## DUNELAND BRUMMITT ELEMENTARY SCHOOL RENOVATIONS Chesterton, IN 46304

## ADDENDUM ONE

Addendum One (AD.01) to the drawings and specifications prepared by Gibraltar Design for **Brummitt Elementary School Renovations** for Duneland School Corporation, Chesterton, Indiana.

#### 6. Sheet P-101

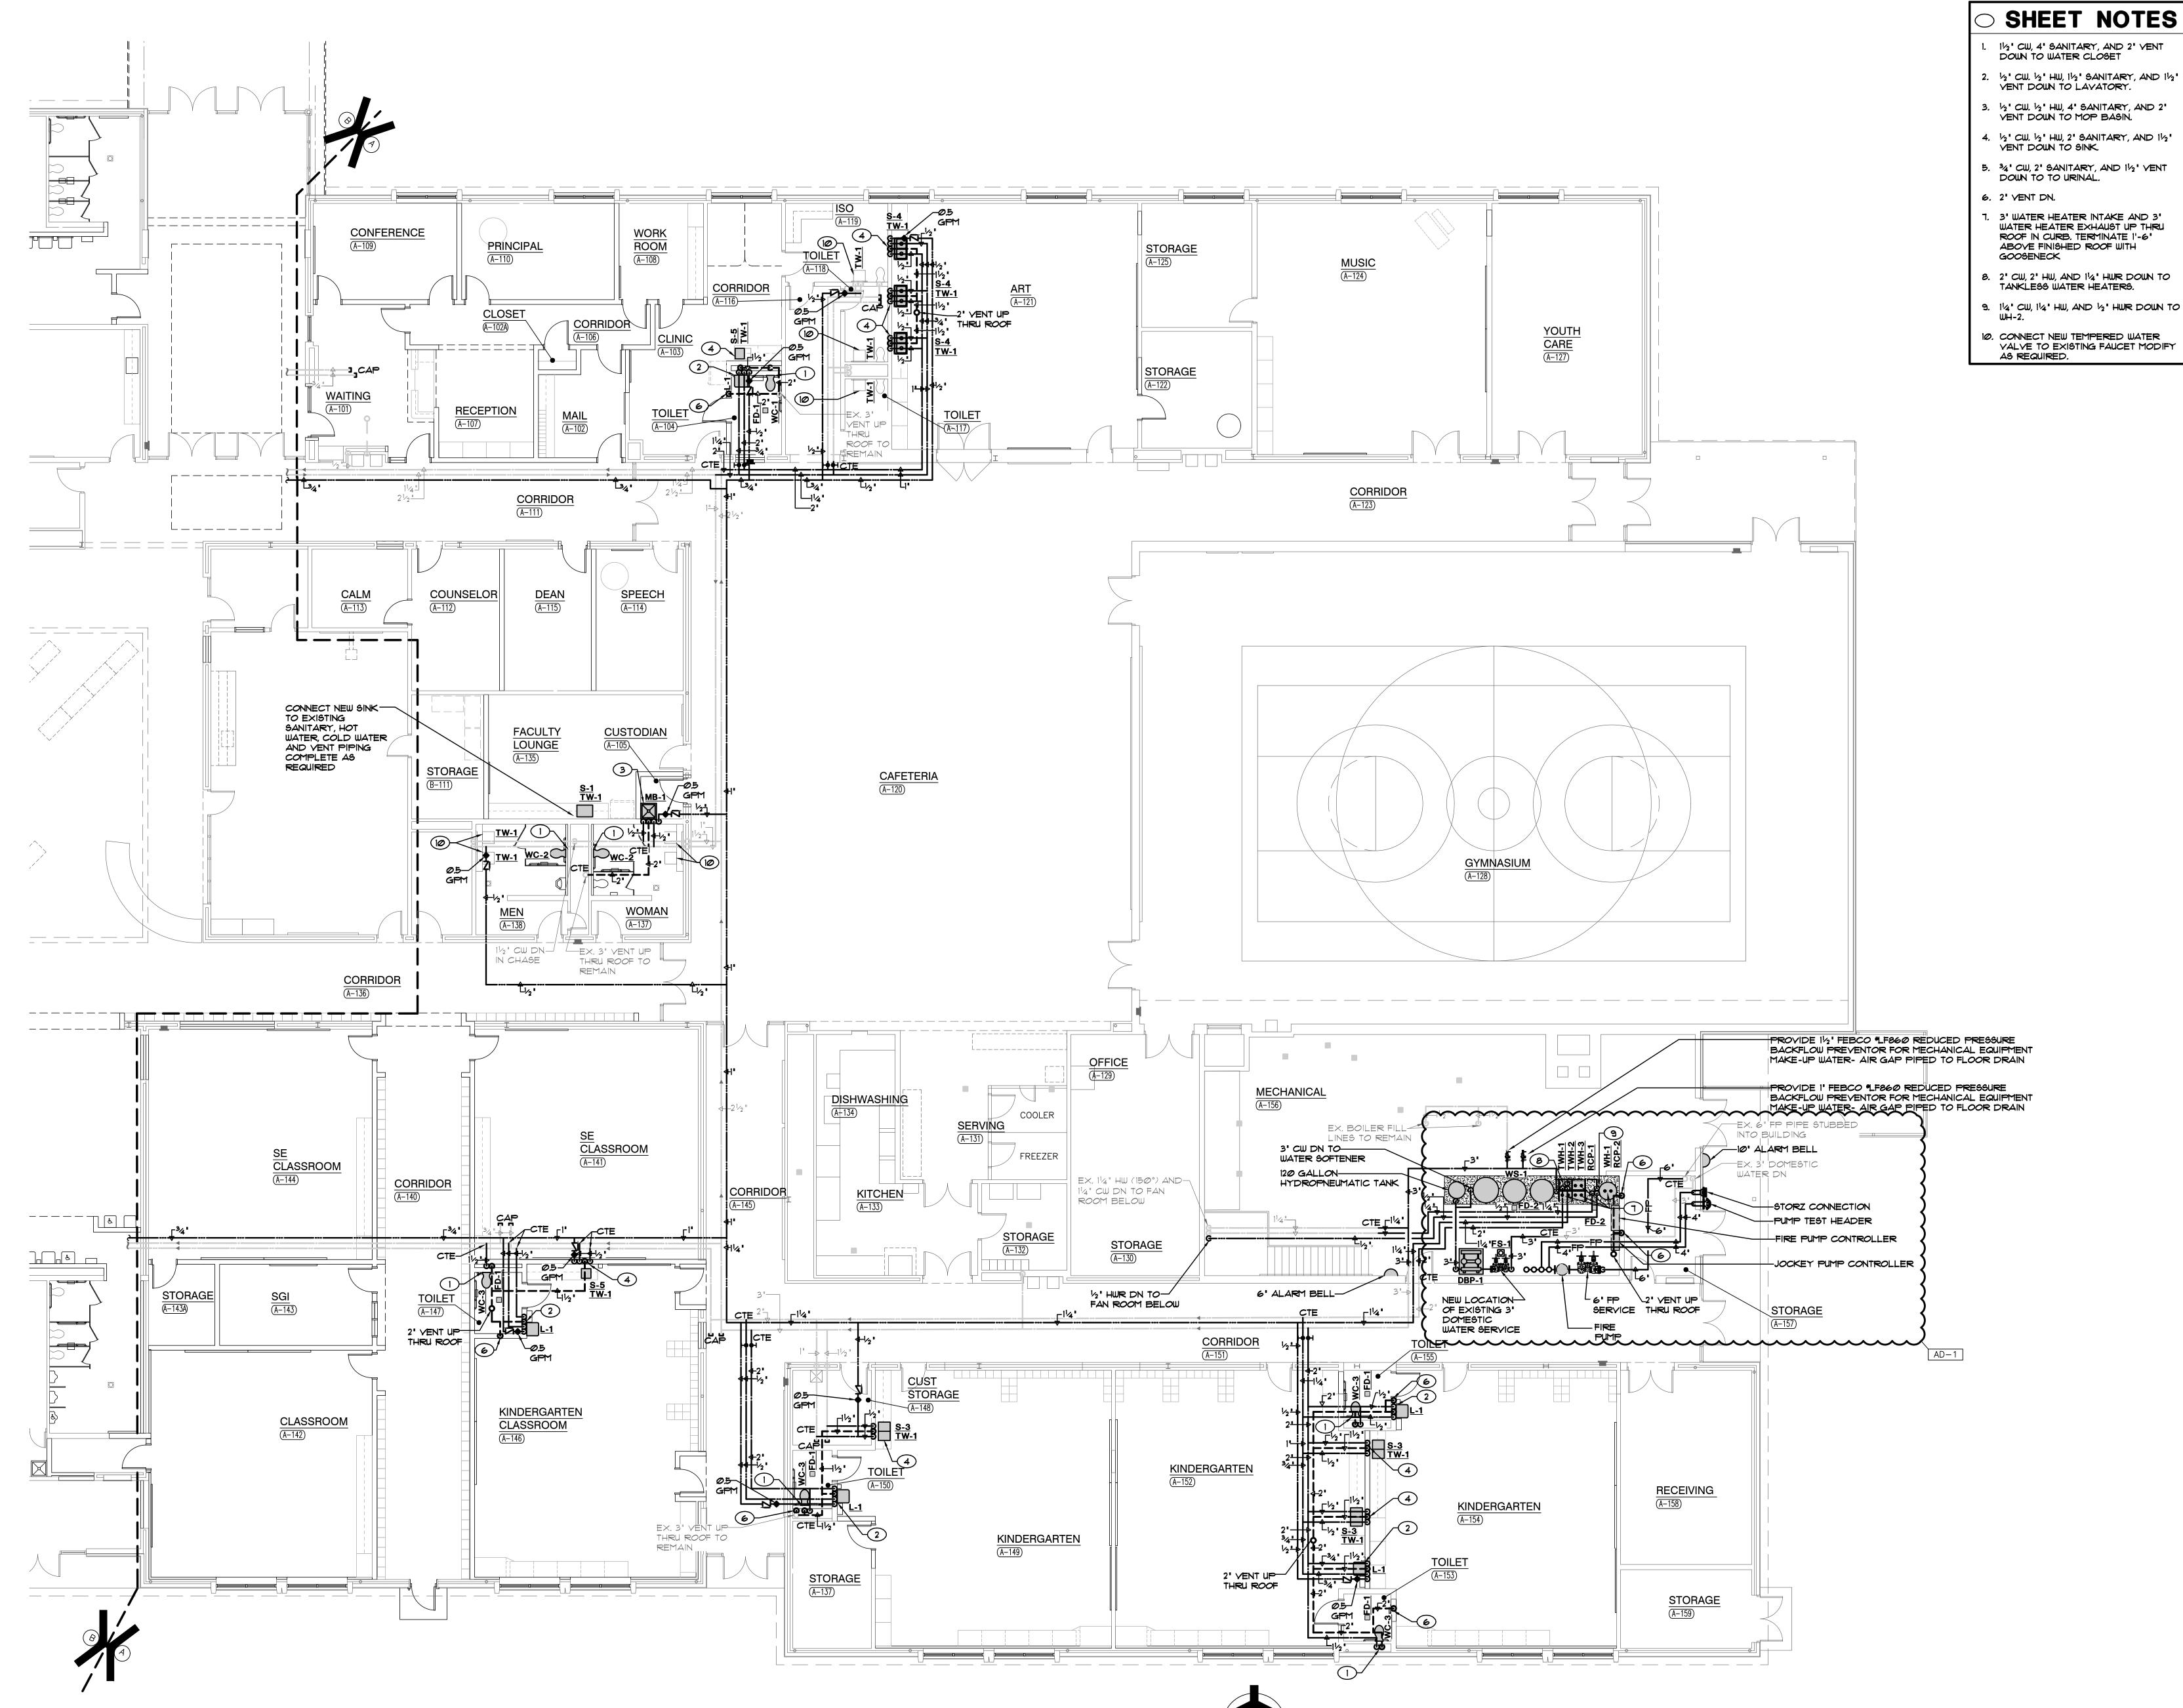
1. Plumbing revisions in Storage A-157.

#### 8. Sheet P-501

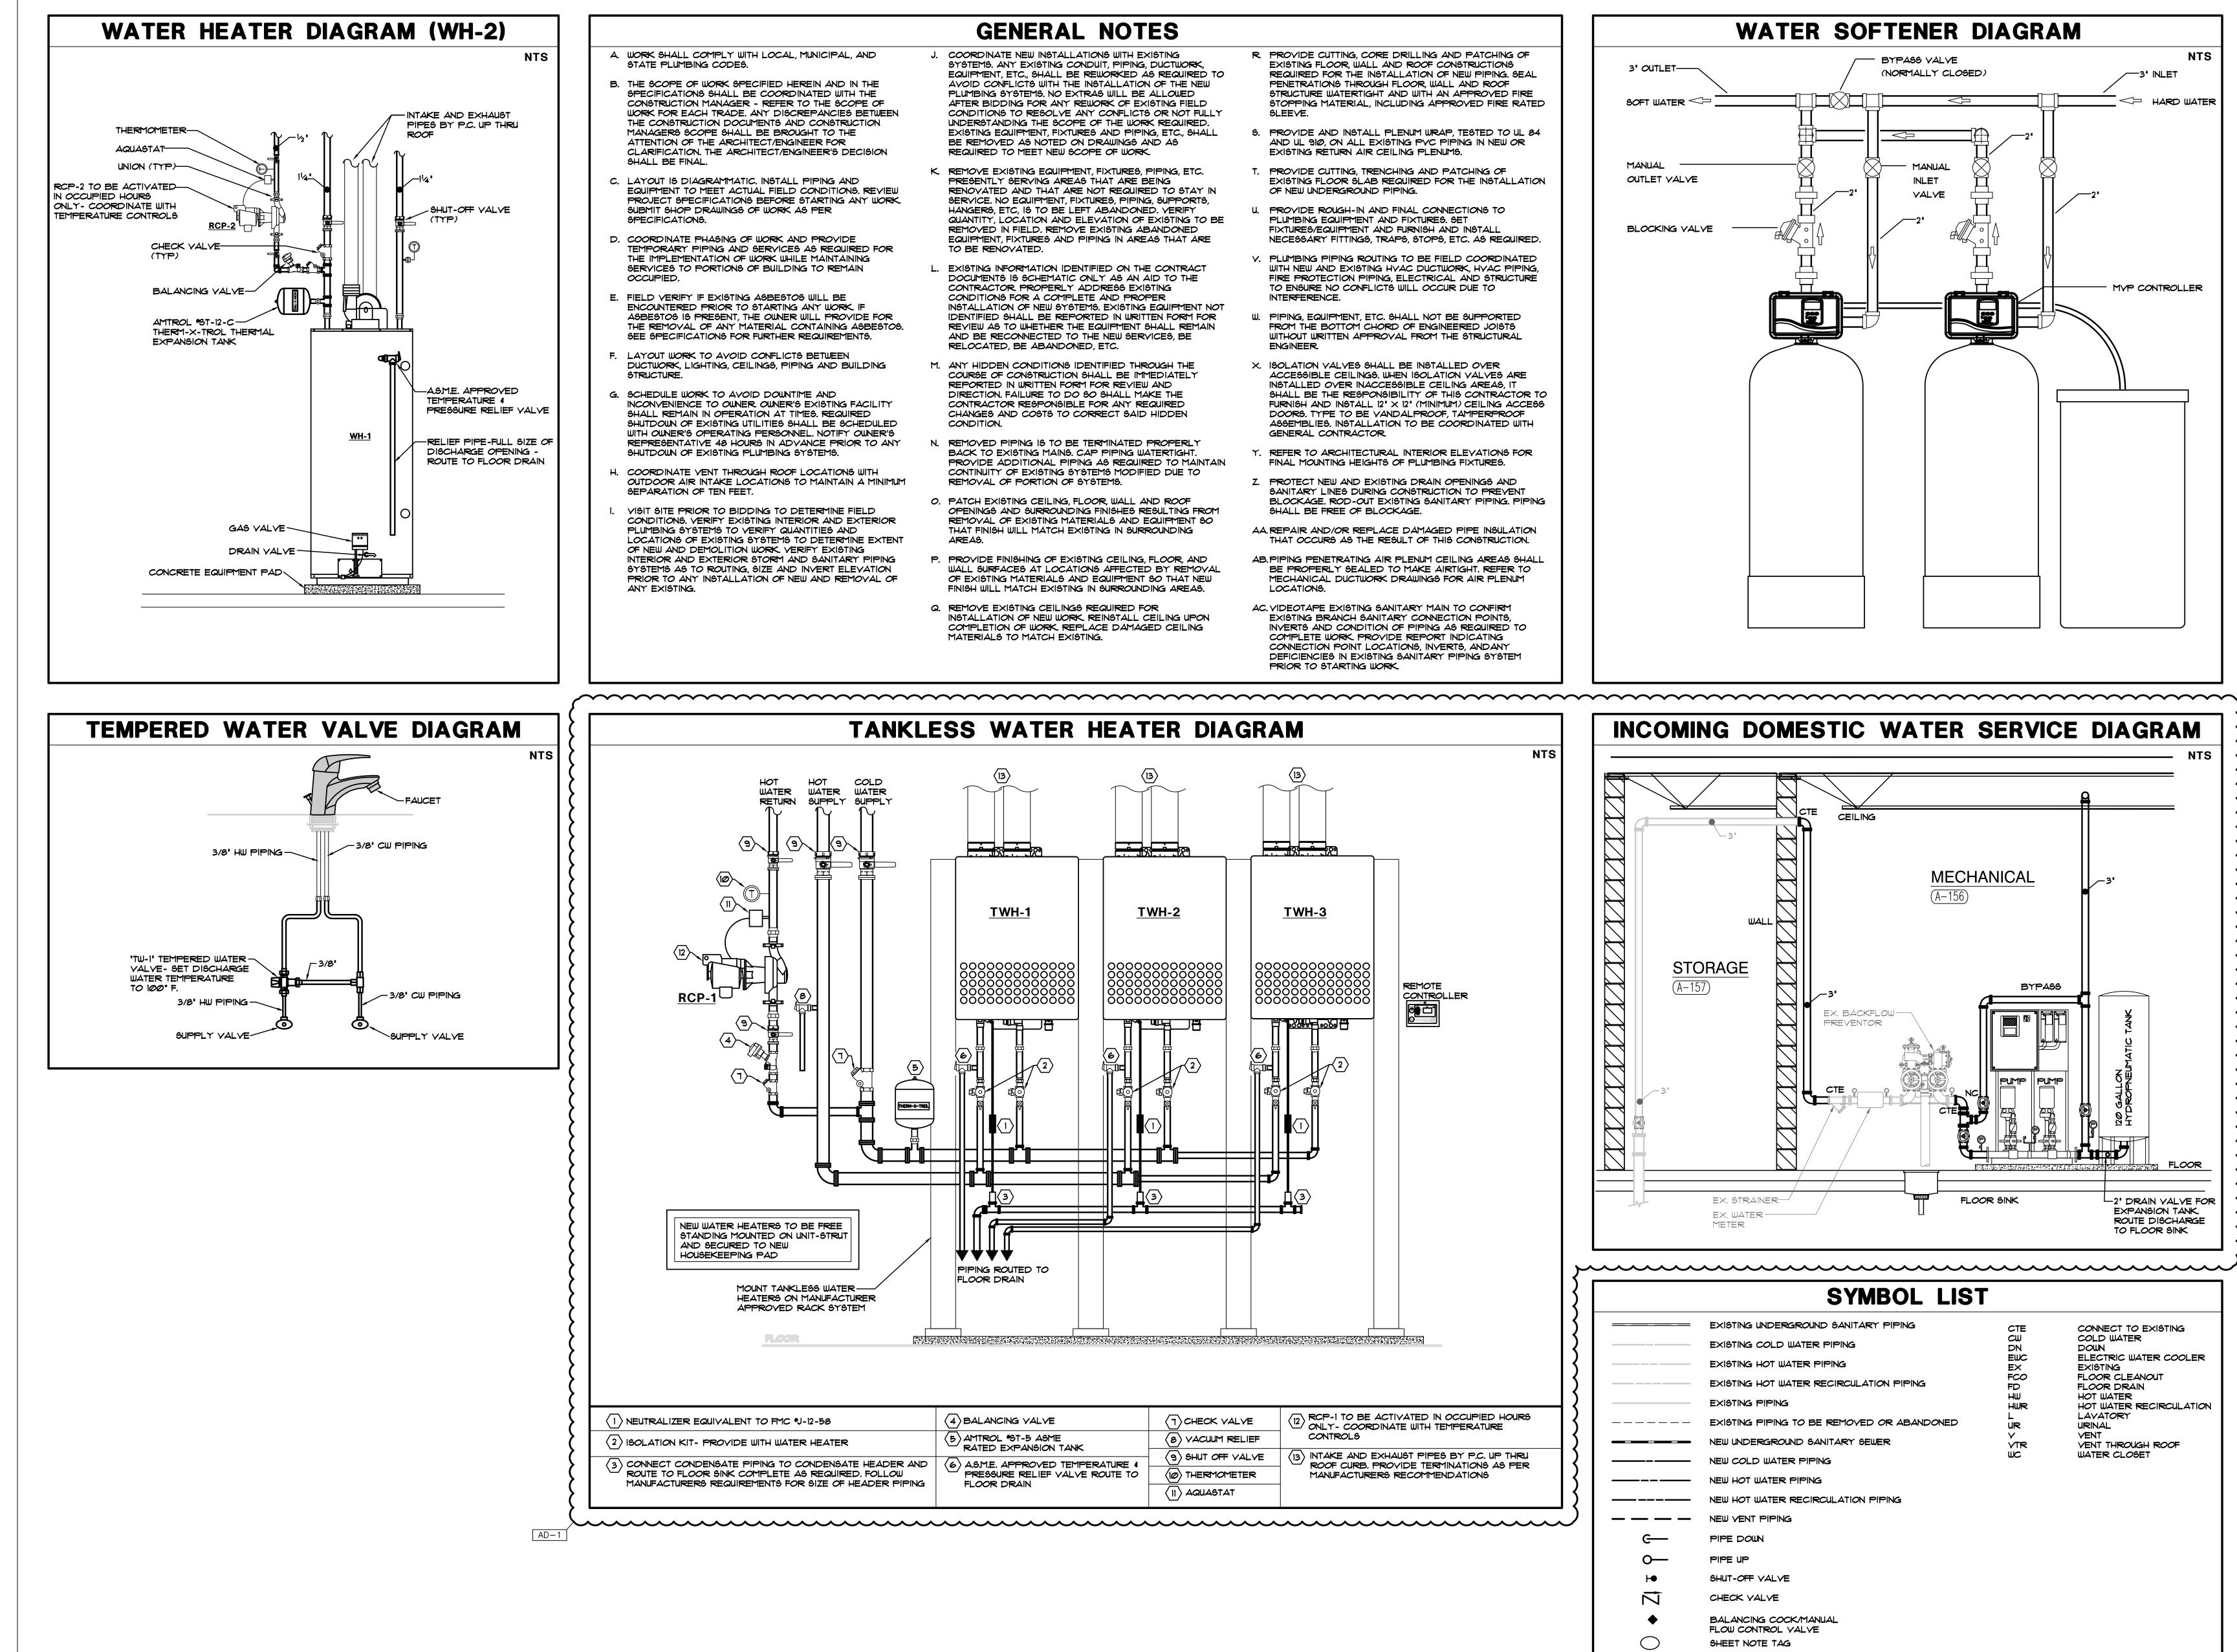
- A. Refer to revised full size drawings, included in this Addendum, for the following revisions:
  - 1. Revisions to the Incoming Domestic Water Service Diagram and the Tankless Water Heater Diagram.
